M9536A-02

**S E R V I C E N O T E**

M9536A - AXIe Embedded Controller

Error occurs when running Agilent Recovery System

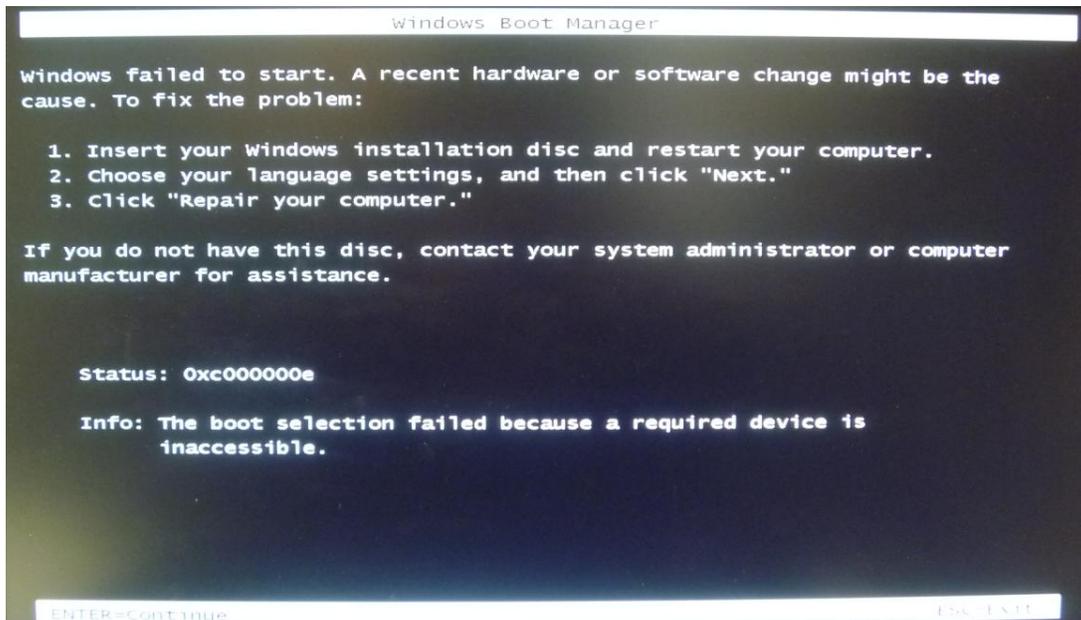
It has been found that M9536A affected model described above will not allow users to run Agilent Recovery System. When users try to run the Agilent Recovery System at the Windows Boot Manager upon booting the M9536A, they get the following error:

There are 2 situations explained below to resolve this issue. Please use the appropriate procedures below to help you recover based on your situation.

**Situation and Solution #1: Working Windows Operating System**

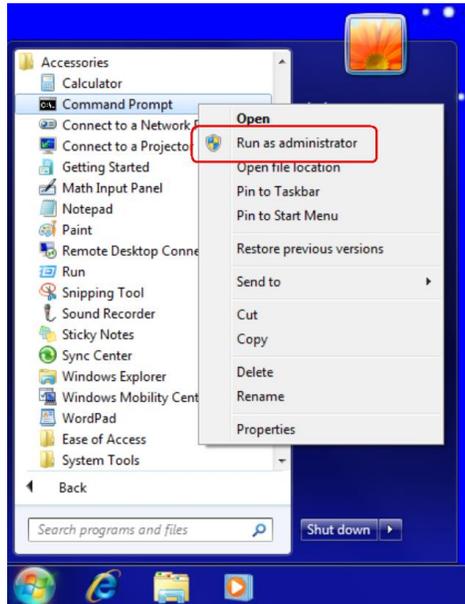
Users are recommended to run the setBCD.bat file from Windows as soon as possible to prevent this issue from happening in the future when they want to run the Agilent Recovery System. Note that after each time the Agilent Recovery System is run, users will need to re-run the setBCD.bat file again to prevent this issue on the next recovery run. Please follow the procedures below to run the setBCD.bat file from Windows:

1. Press on the Start button and right click on Command Prompt
2. Select Run as administrator

3. At the Administrator: Command Prompt window, cd to “C:\Agilent\Scripts”
4. Then type in “SetBCD.bat” and press Enter
5. After the two notifications of “The operation completed successfully.”, you may close the Command Prompt window.

### Situation and Solution #2: Corrupted Windows Operating System but “Safe Mode with Command Prompt” is Accessible

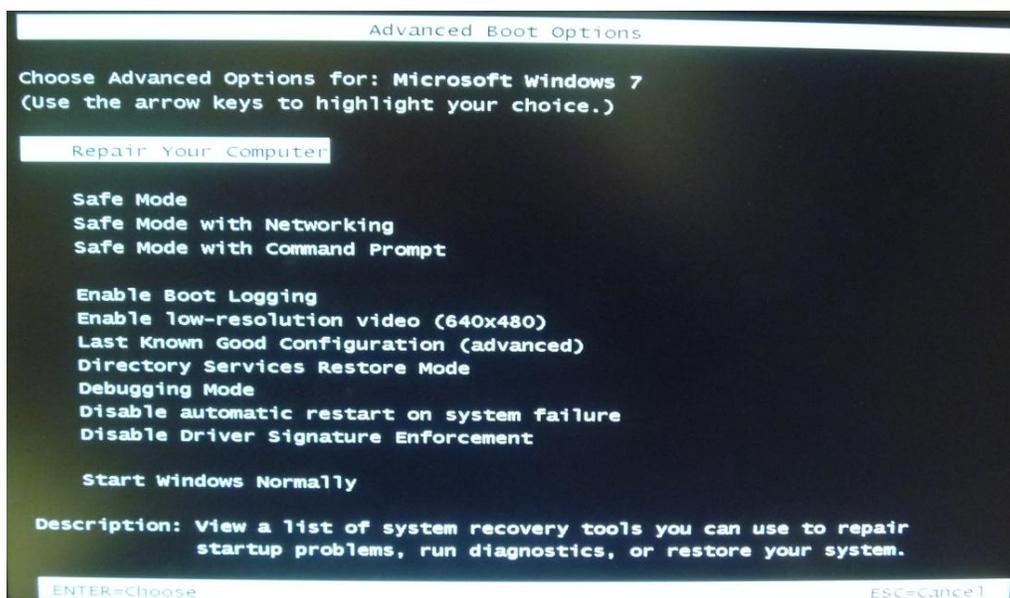
Users who have corrupted Windows but are able to access to the Advanced Boot Options, they can run the setBCD.bat file from “Safe Mode with Command Prompt”. Please follow the procedures below to run the setBCD.bat file from “Safe Mode with Command Prompt”:

1. Press F8 at the Windows Boot Manager screen to enter into the Advanced Boot Options

2. At the Advanced Boot Options screen, select “Safe Mode with Command Prompt” and press Enter.

3. At the Safe Mode Administrator: cmd.exe window, cd to “C:\Agilent\Scripts”
4. Then type in “SetBCD.bat” and press Enter
5. After the two notifications of “The operation completed successfully.”, you may press Ctrl+Alt+Del to restart the computer.
